Peer Review of Demonstrating the Safety and Crashworthiness of a 2020 Model-Year, Mass-Reduced Crossover Vehicle (Lotus Phase 2 Report)

EPA-420-R-12-028
September 2012

SUBJECT: Peer Review of *Demonstrating the Safety and Crashworthiness of a 2020 Model-Year, Mass-Reduced Crossover Vehicle (Lotus Phase 2 Report)*, developed by Lotus Engineering, Inc.

Figure 1. Material assignments in the front end.

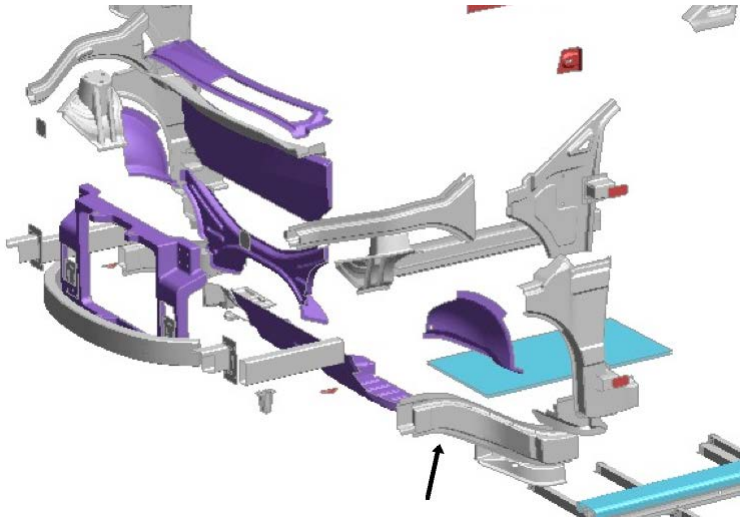
These assignments were not possible to confirm from the crash model since the input files were encrypted. In any case, since Mg AM60 alloy is used in such important role for the frontal crash, a more detailed material model than the one implied by the graph on page 32 of Phase 2 report [1] would be warranted. More accurate failure model is needed, as well. The failure criteria in LS-DYNA [6] are mostly limited to threshold values of equivalent strains and/or stresses. However, combination of damage model with plasticity and damage-initiated failure would probably yield a better accuracy for AM60.

Figure 2. Joint between the front-end module and the crush rail.

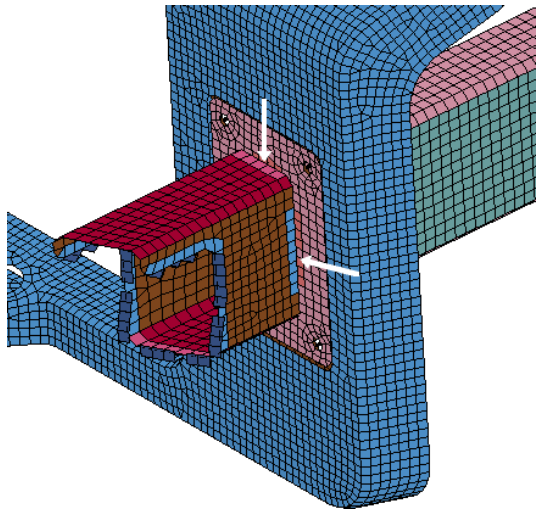
This particular connection contains welds (for joining aluminum parts) and bolts (for joining aluminum and magnesium). HAZ properties were not given in the report and they could not be checked in the model due to encryption. The bolt model properties were described that it fails at 130 MPa (page 38 of the report [1]), which corresponds to the yield stress of AM60. The importance of these joints cannot be overstated. They enforce stability of the axial deformation mode in the rails that in turn enables dissipation of the impact energy. The crash sequence of the connection between the front end module and the front rail is shown in Figure 3.

Figure 3. Crush of the front rail and front end module connection.

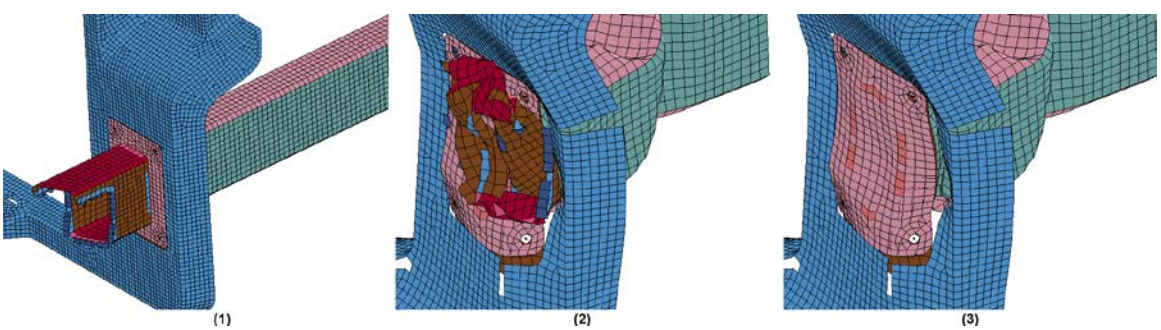
The cracks in the front end module (Figure 3.2) and the separation between the front end module and the front rail (Figure 3.3) are clearly visible. This zone experiences very large permanent deformations, as shown in Figure 4.

Figure 4. Plastic deformation distribution in the front end joint. Colors denote magnitude of the equivalent plastic strain.

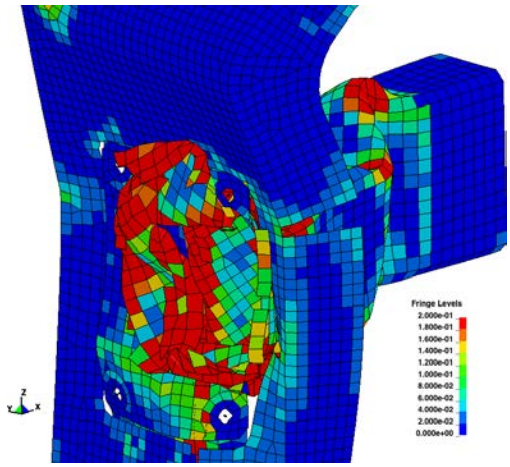
It is not clear from the simulations which failure criterion dominates the process. Is it the failure of the HAZ or is it the spot weld limit force or stress. Given the importance of this joint on the overall crash response, additional information about the joint sub-models would be very beneficial to a reader.

Figure 5. Plastic deformation distribution in the front end connection

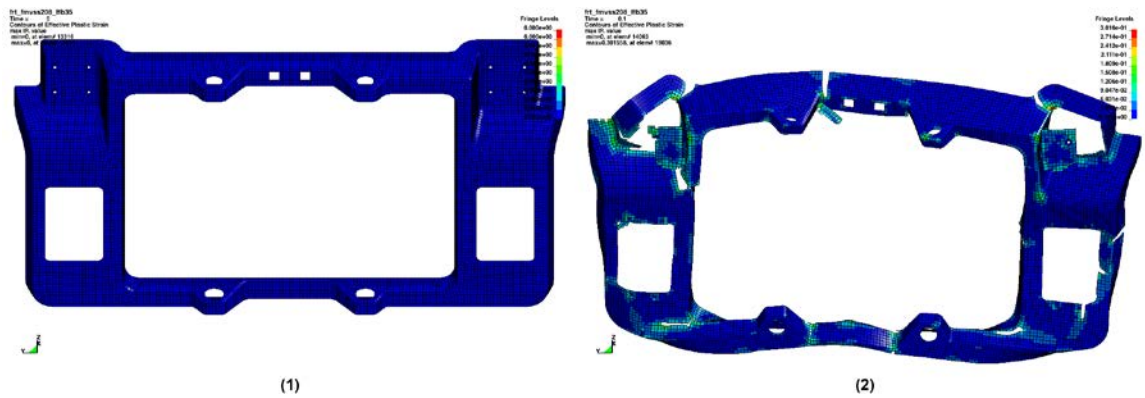
Notice large cracks open in the mid span, on the sides, and punched out holes at the locations of the connection with the front rail and the shotgun. Mesh refinement study of this component would be interesting and could also indicate the robustness of the design. Decision to design such a structurally important part out of Mg would be interesting to a reader.

Figure 6. Constraints for controlling the crush of the front rail

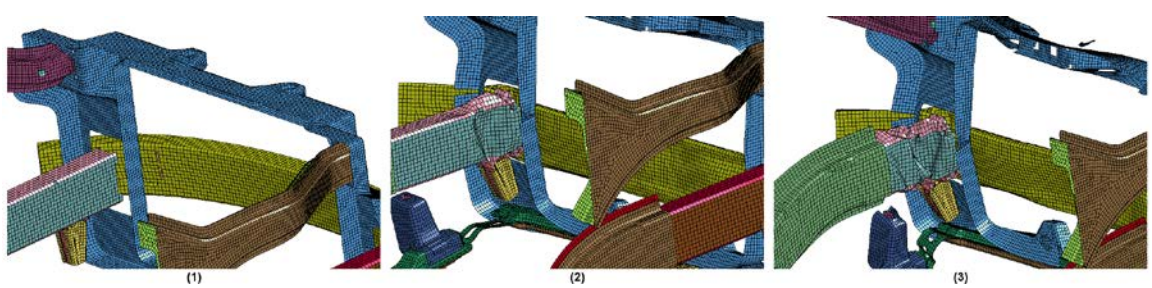
The axial crash of the front rails is ensured by their connection to the front end, rear S-shaped support and to the connections to the sub-frame. Figure 7 shows the detail of the connectors between the left crush rail to the subframe.

Figure 7. Connections between the front rail and the subframe

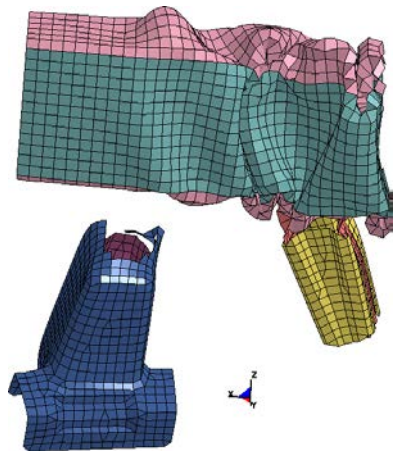
Tearing of the top of the support (blue) can be clearly observed in Figure 8. The importance of this connection for the overall response may warrant parametric studies for failure parameters and mesh discretization.

Figure 8. Accelerometers at the bases of B-pillars

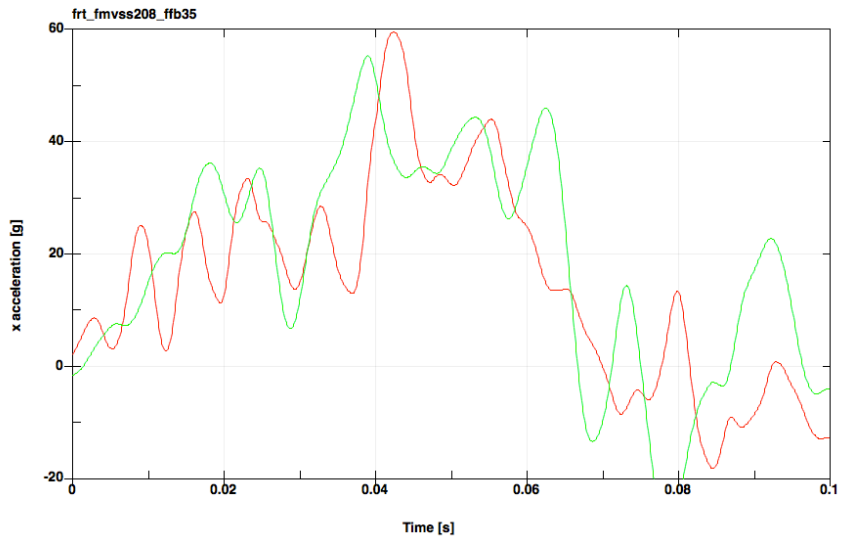
The two accelerometer traces from the simulation at the lower B-pillar locations are shown in Figure 8. When compared with NHTSA test 6601, the simulation accelerometer and displacement traces indicate much shorter crush length than the baseline vehicle.

Figure 9. Top view of the crash deformation during NCAP test

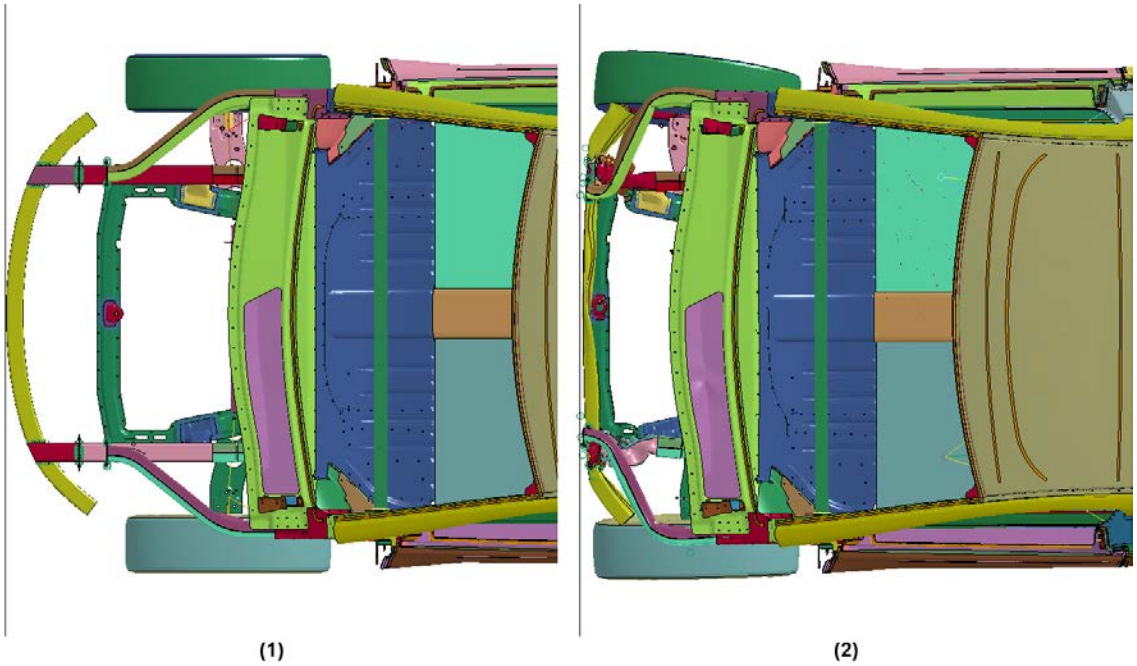
It can be seen that almost all deformation occurs in the space spanned by the front frame rails. As marked in Figure 1, the front transition member (or a differently named component in case my material assignment assumption was not correct), supports the front rail so that it axially crushed and dissipated as much energy, as possible. For that purpose, this front rail rear support was made extremely stiff and it does not appreciably deform during the crash (Figure 10). It has internal reinforcing structure that has

not been described in the report. These reinforcements enables it to reduce bending and axial deformations in order to provide steady support for the axial crush of the aluminum rail tube.

Figure 10. Configuration of the front rail support

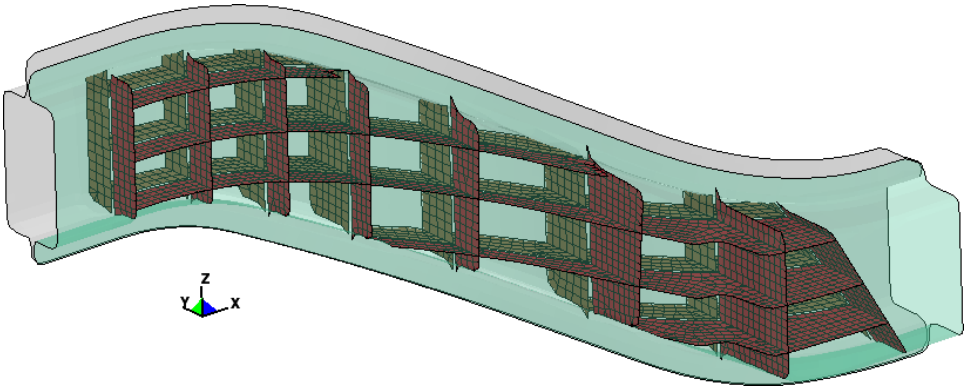
This design decision reduces the possible crush zone and stopping distance to the distance between the front of the bumper and the front of the rail support (Figure 9). The effective crash length can be clearly seen in Figure 11.

Figure 11. Crush zone for NCAP test

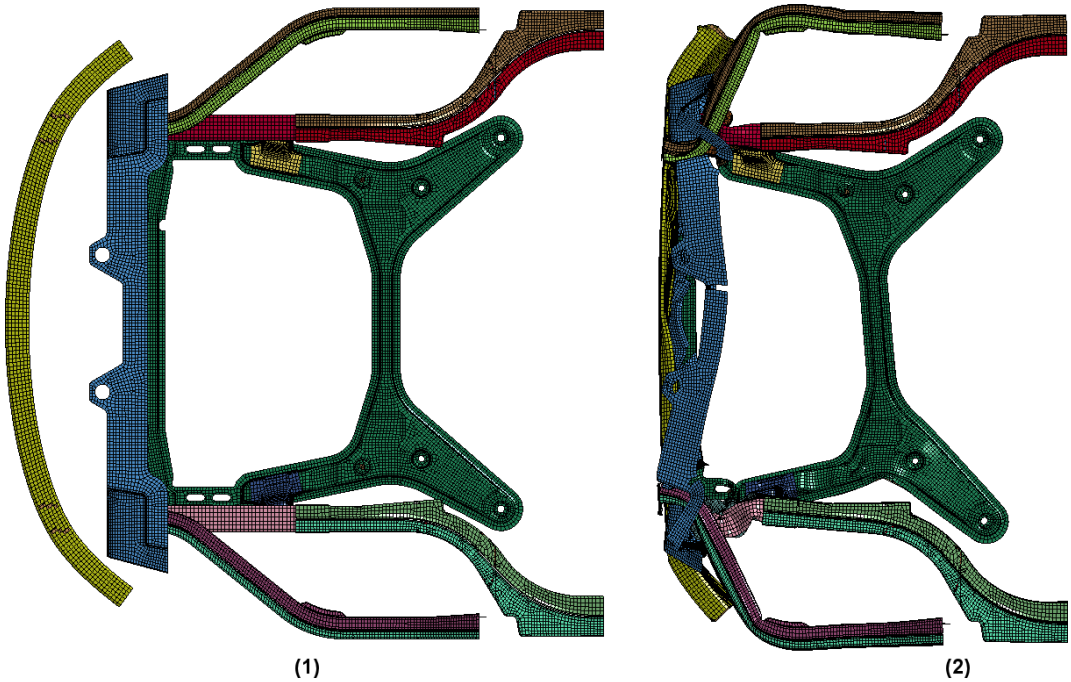
We can see from the above figure that the front rail supports undergo minimal displacements and that all the impact energy must be dissipated in a very short span. Figure 12 shows the points of interest to

Figure 12. Points of interest for determining crush zone

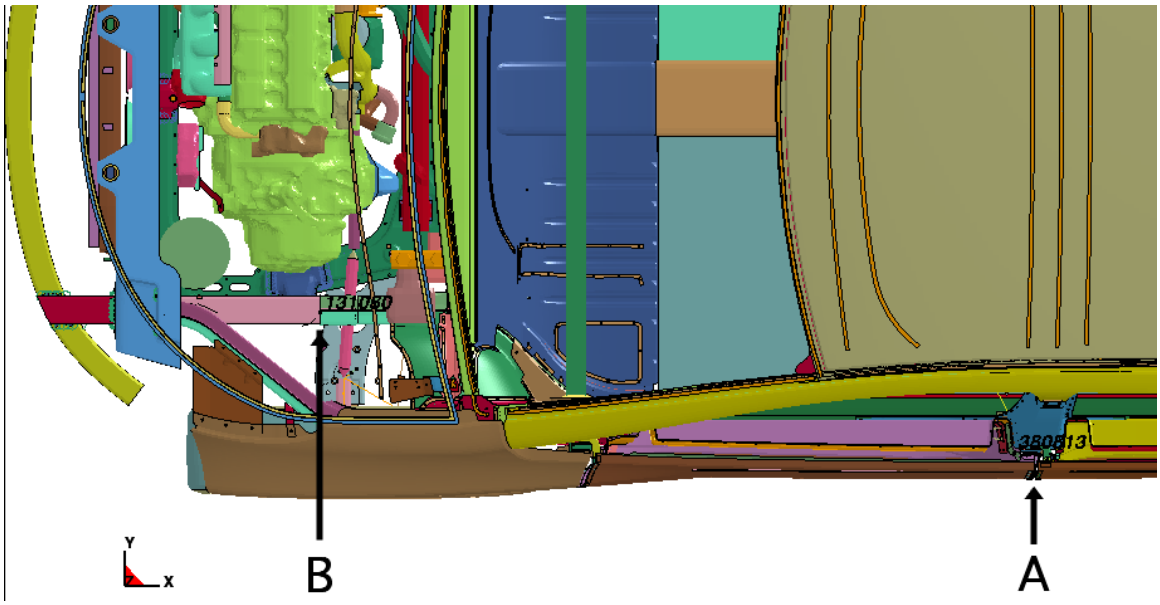
Figure 13 gives the history of the axial displacements for the two points above. At their maximum points, the relative reduction of their distance from the starting condition is 0.7 inches.

Figure 13. X displacements of the base of B-pillar (A) and front of the support rail (B) for the NCAP test

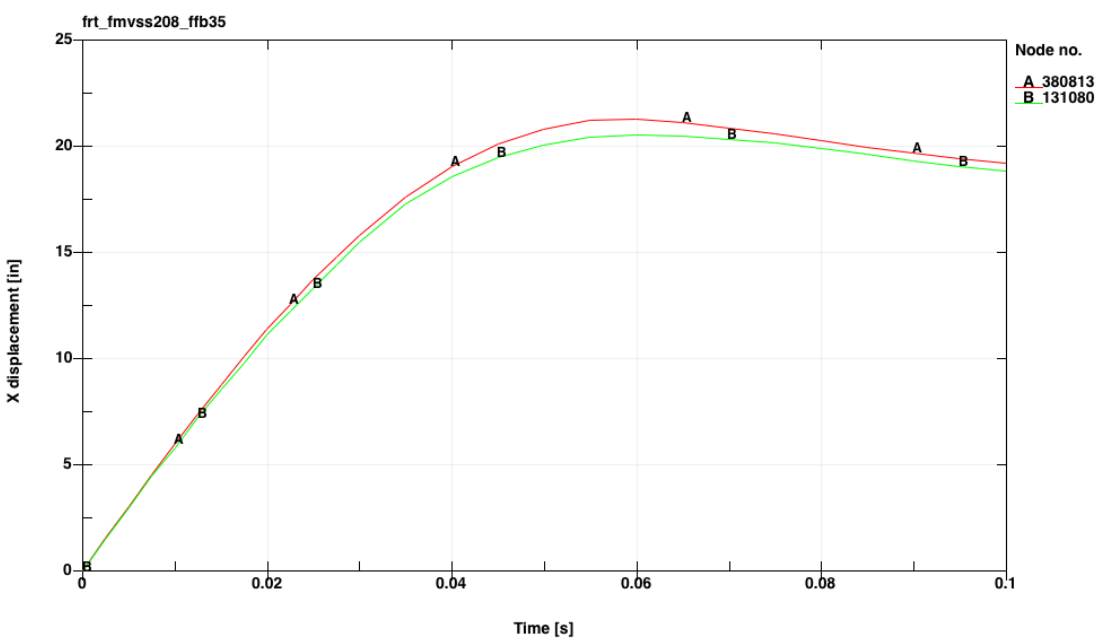
Since the distance between the front of the rail support and the rocker remains practically unchanged during the test, we can reasonably assume that majority of the crash energy is dissipated in less than 22 inches. To quickly evaluate the feasibility of the proposed design, we can use the concept of the Equivalent Square Wave (ESW) [11]. ESW assumes constant, rectangular, impact pulse for the entire length of the stopping distance (in our case equal to 22 in) from initial velocity (35 mph). ESW represents an equivalent constant rectangular shaped pulse to an arbitrary input pulse. In our case ESW is about 22g. Sled tests and occupant model simulations indicate that crash pulses exceeding ESW of 20 g will have difficulties to satisfy FMVSS 208 crash dummy performance criteria [11]. For a flat front barrier crash of 35 mph and an ESW of 20 g, the minimum stopping distance is 24 in. Advanced restraint systems and early trigger airbags may need to be used in order to satisfy the injury criteria and provide sufficient ride down time for the vehicle occupants.

Figure 14. Crush zone of the front structure during the NCAP test.

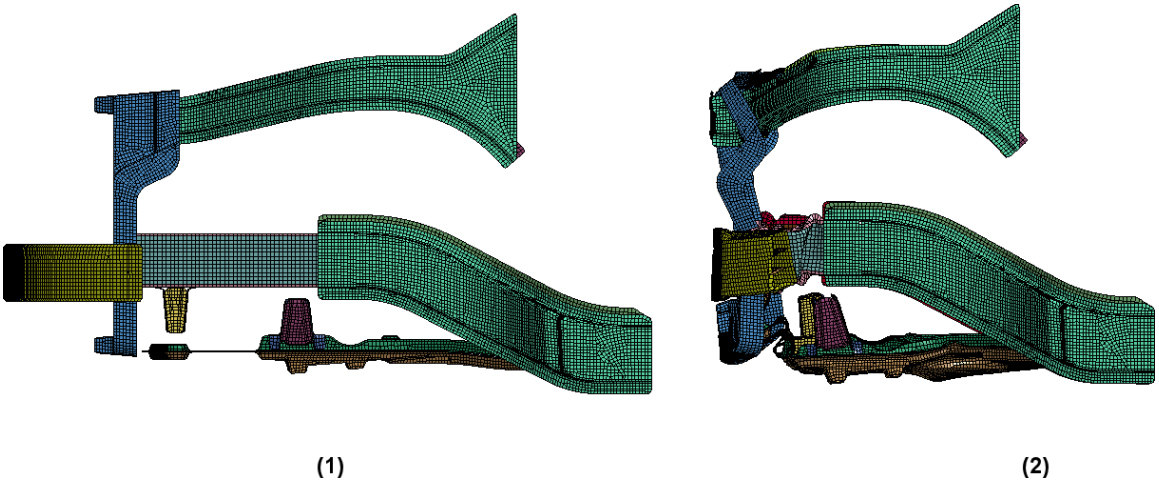
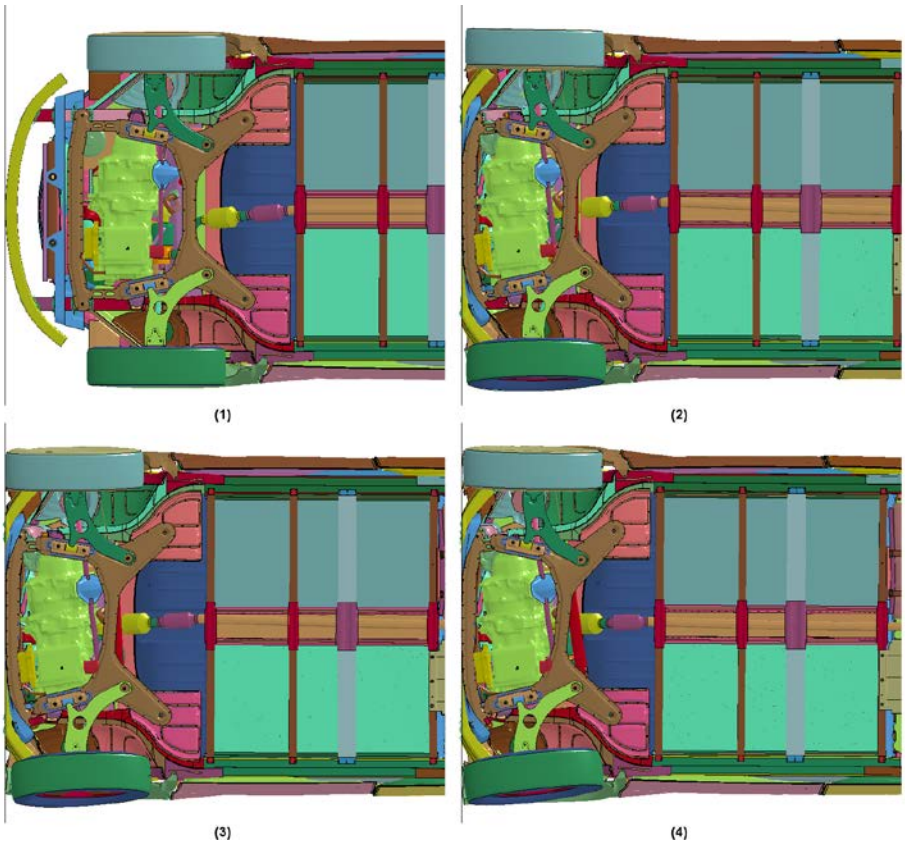
One of the intriguing differences between the simulations and baseline vehicle crash test is the amount and the type of deformation in the frontal crash. As noted previously, computational model is very stiff with very limited crush zone. Viewed from the left side (Figure 14), and from below (Figure 15), we can see that the majority of the deformation is in the frame rail, and that the subframe's rear supports do

not fail. The strong rear support to the frame rail, does not appreciably deform, and thereby establishes the limit to the crash deformation.

Figure 16. Overall vehicle kinematics for the NCAP test.

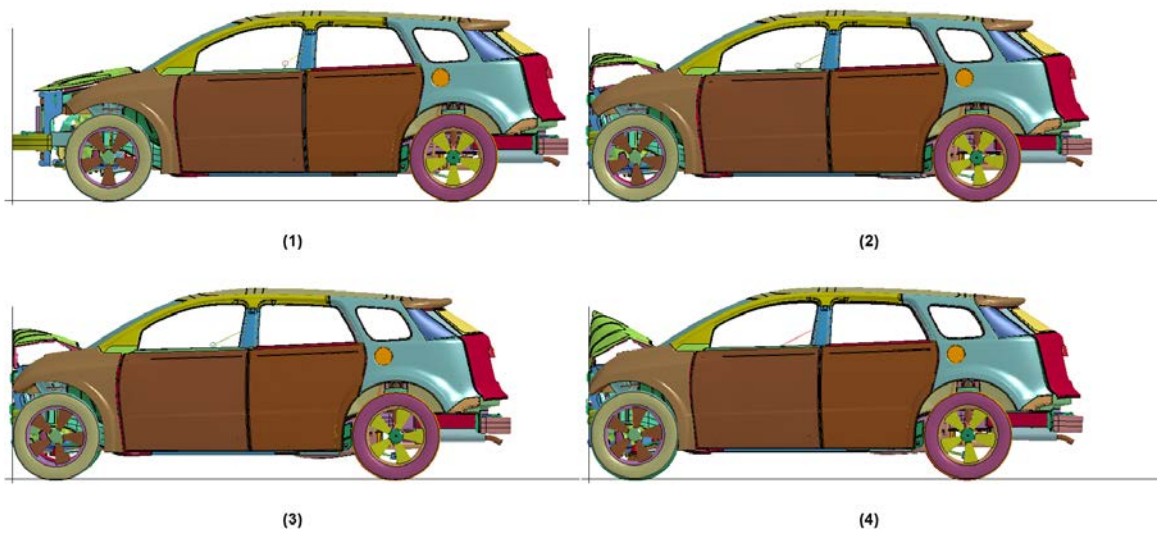
The numbers 1-4 below the images denote times after impact of 0ms , 35ms, 40 ms, and 75ms, respectively. The times were selected based on characteristic event times observed in crash simulations.
